From: Kevin Kamps <kevin@beyondnuclear.org>
Sent: Monday, October 5, 2020 4:25 PM
To: WCS_CISFEIS Resource
Subject: [External_Sender] Beyond Nuclear's 2nd set of public comments, re: Docket ID NRC-2016-0231, and report number NUREG-2239, NRC's ISP/WCS CISF DEIS -- Risks of "Routine" or "Incident-Free" Shipments Nonetheless Being Like "Mobile X-ray Machines That Can...
Attachments: DC States_Affected.pdf; VA States_Affected.pdf; Maryland States_Affected.pdf; Figure 4.2-3 Transportation Routes Page 4-65 Revision 0 of ER Waste Control Specialists, LLC, Consolidated Interim Spent Fuel Storage Facility Environmental Report, Rev. 0, Chapter 4, 1 of 2. - ML16133A158.pdf

Risks of "Routine" or "Incident-Free" Shipments Nonetheless Being Like "Mobile X-ray Machines That Can't Be Turned Off," and Risks of Externally Contaminated Shipments

Figure 7 FSEIS Routes through the District of Columbia

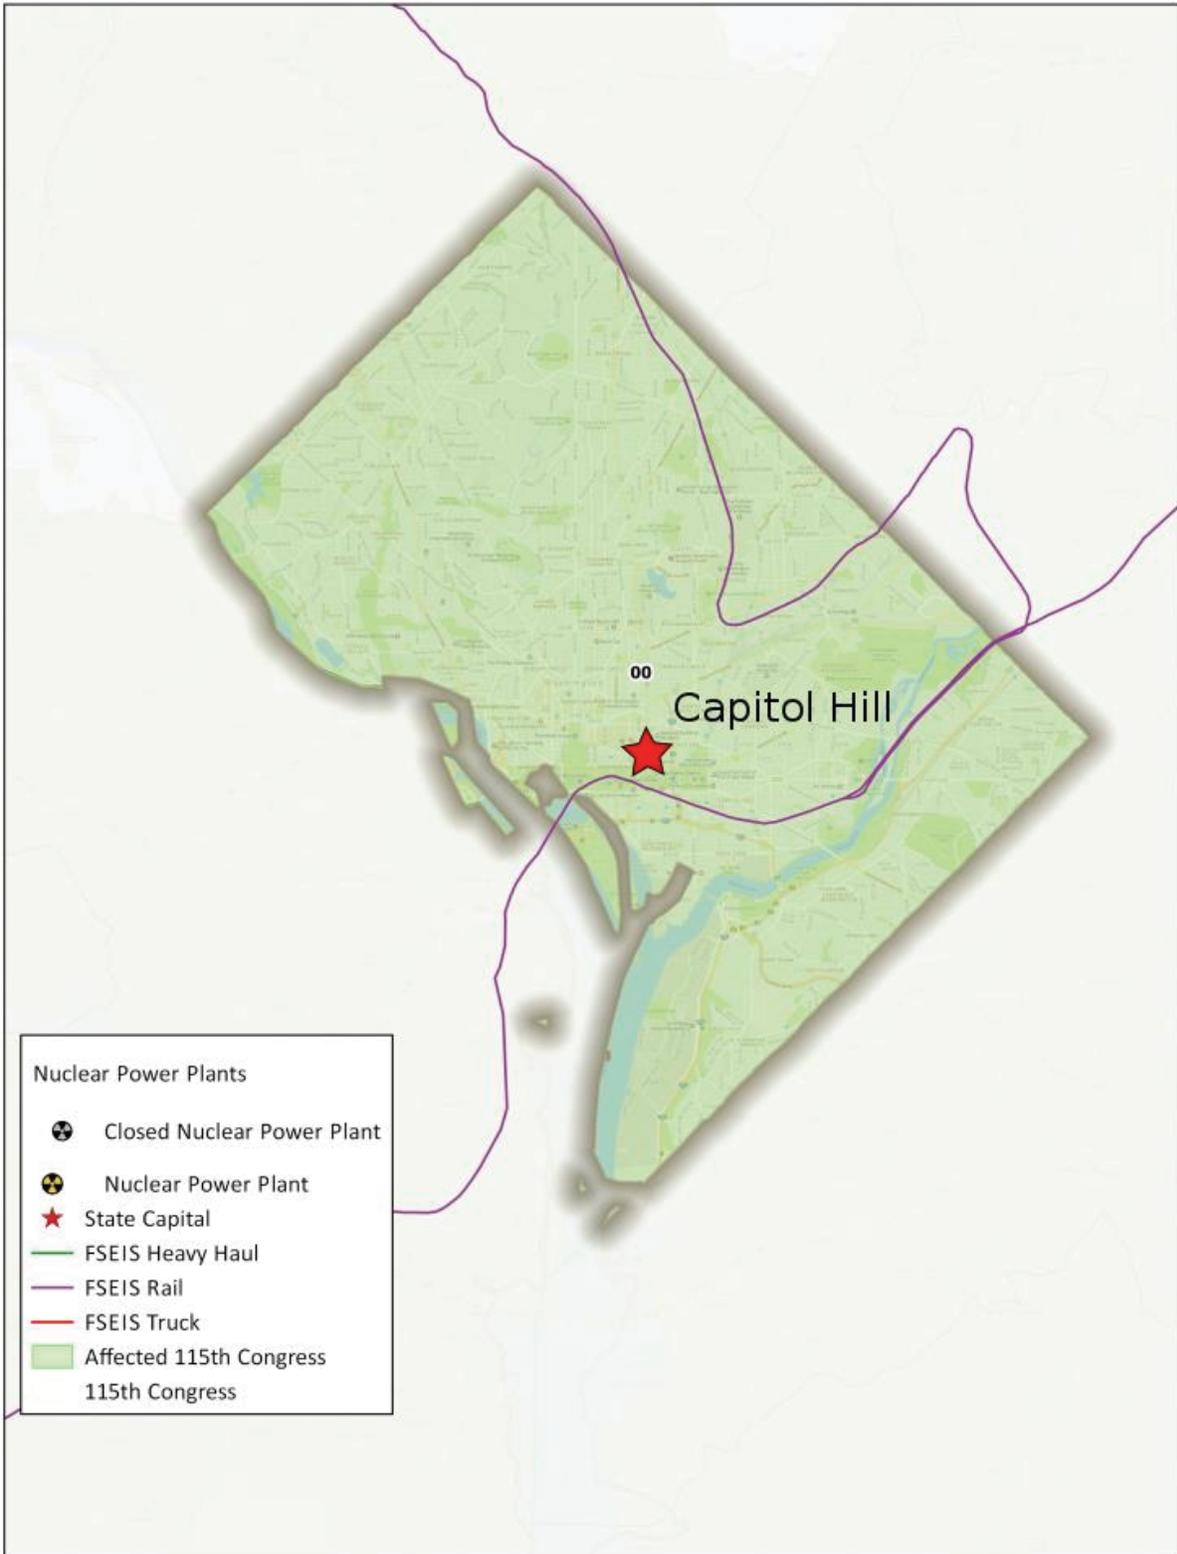
The map shows a rail route for hauling irradiated nuclear fuel through metro Washington, D.C., including Takoma Metro Station -- just shy of Silver Spring, Maryland -- bound for the Yucca

It must be pointed out that as far east as metro Washington, D.C., the routing would be identical, whether shipments were bound for Holtec's CISF in NM, ISP's CISF in TX, or the Yucca Mountain, NV dump, on Western Shoshone land.

Figure 41 FSEIS Routes through Virginia

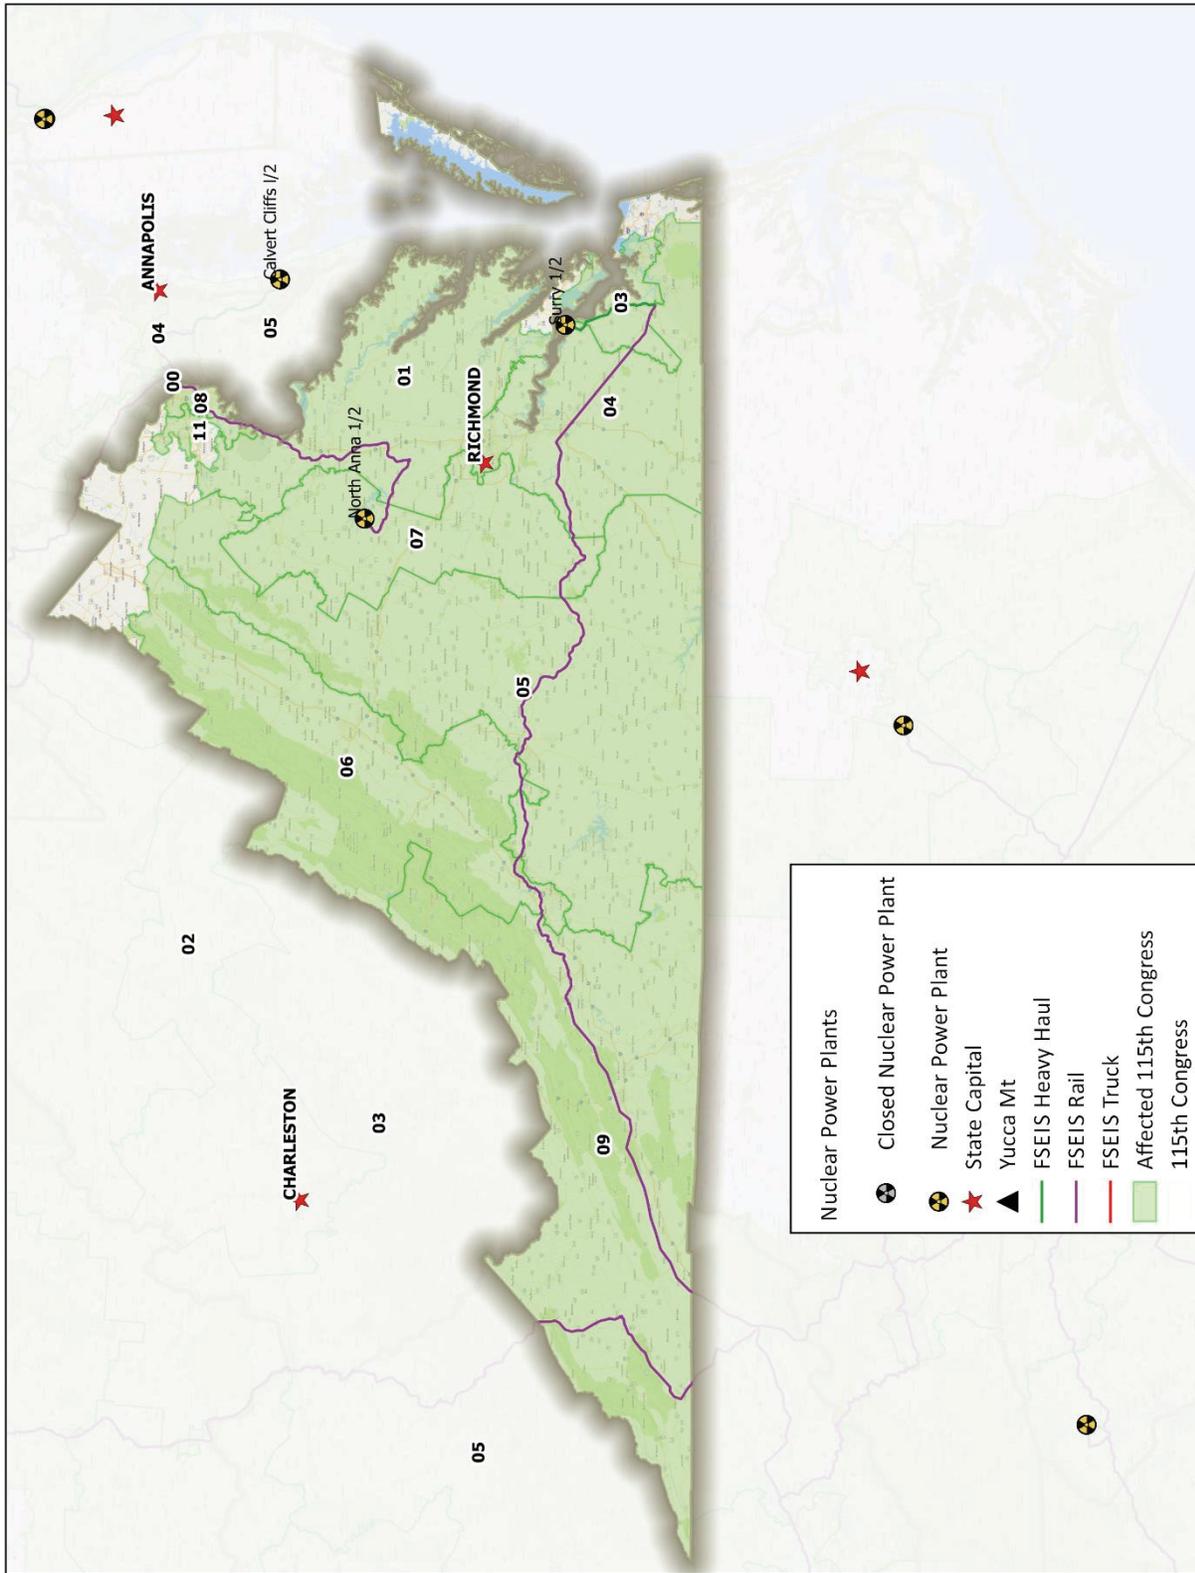
Please note that the route passing through Takoma Metro Station, coming from Virginia to the southwest, would haul North Anna nuclear power plant irradiated nuclear fuel. This is clearly shown on Page 41 of 45 on the PDF Counter, in this document:

Figure 19 FSEIS Routes through Maryland

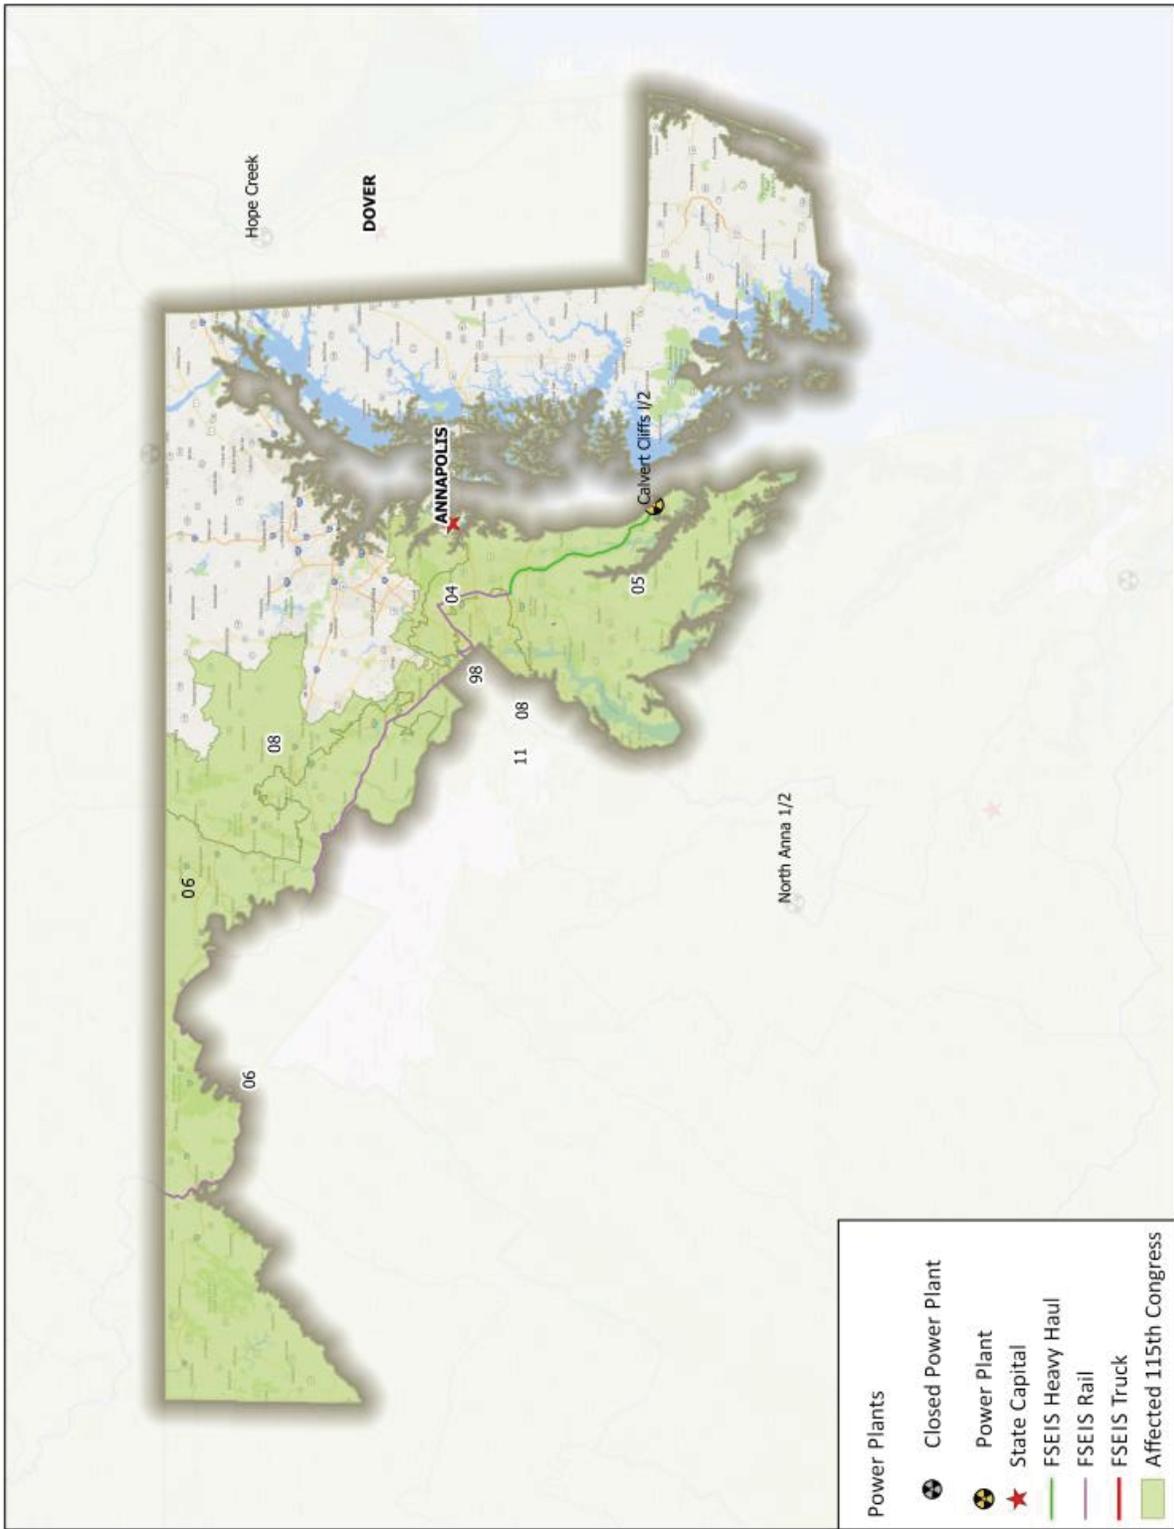
Similarly, please note that the route passing through Takoma Metro Station, coming from Maryland to the east, would haul Calvert Cliffs nuclear power plant irradiated nuclear fuel. This is clearly shown on Page 19 of 45 on the PDF Counter, in this same document:
